# Access Compliance Report

## Public Rights-of-Way

Intersection ID: 3720	Main Street: DAVIS_LAKE_PY	Cross Street: FORTUNES_RIDGE_TL	Location:	N
ADA ID: 43ED1E344412	Ramp Type: Perp	Initial Pass/Fail: Fail	Overall Compliance: No	Severity Score: 12.5

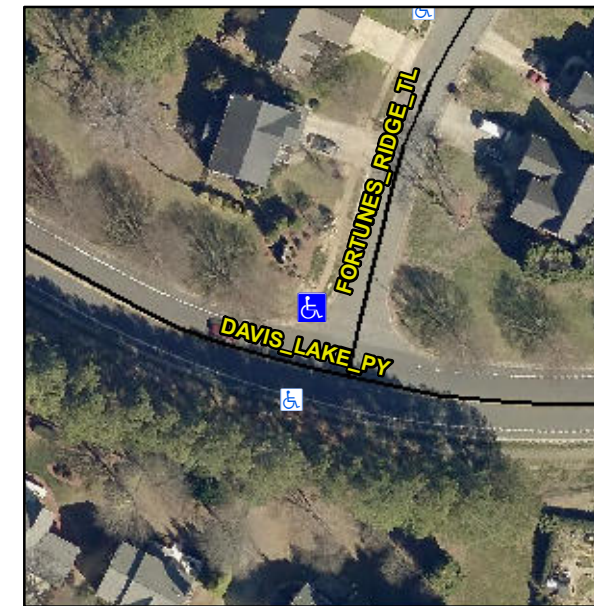
**Not Found, R304.5.3**

Compliance	Description	Data	Compliance	Description	Data
N/A	Ramp Length (in)	54.0	Yes	Ramp Slope (%)	6.4
Yes	Ramp Width (in)	48.0	No	Ramp XSlope (%)	5.6
N/A	Flare Type LT	N/A	N/A	Flare Type RT	N/A
N/A	Flare Slope LT (%)	N/A	N/A	Flare Slope RT (%)	N/A
N/A	Flare Traversable LT?	N/A	N/A	Flare Traversable RT?	N/A
N/A	Landing Length (in)	N/A	N/A	DWS Provided?	N/A
N/A	Landing Width (in)	N/A	N/A	DWS Contrast?	N/A
N/A	Landing Slope (%)	N/A	N/A	DWS Length (in)	N/A
N/A	Landing X Slope (%)	N/A	N/A	DWS Full Width?	N/A
N/A	Landing Curb? (Y/N)	N/A	N/A	DWS Offset (in)	N/A
N/A	Shared Landing?	N/A			
N/A	Gutter Ponding?	N/A	N/A	Gutter Slope (%)	N/A
N/A	Gutter Lip Ht (in)	N/A	N/A	Gutter X Slope (%)	N/A
N/A	Painted X Walk1?	No	N/A	Painted X Walk2?	N/A
	X Walk 1 Direction	To SW		X Walk 2 Direction	N/A
N/A	X Walk 1 Width (in)	N/A	N/A	X Walk 2 Width (in)	N/A
	X Walk 1 Slope (%)	3.9		X Walk 2 Slope (%)	N/A
	X Walk 1 X Slope (%)	2.0		X Walk 2 X Slope (%)	N/A

**Remove & Replace Entire Ramp.**
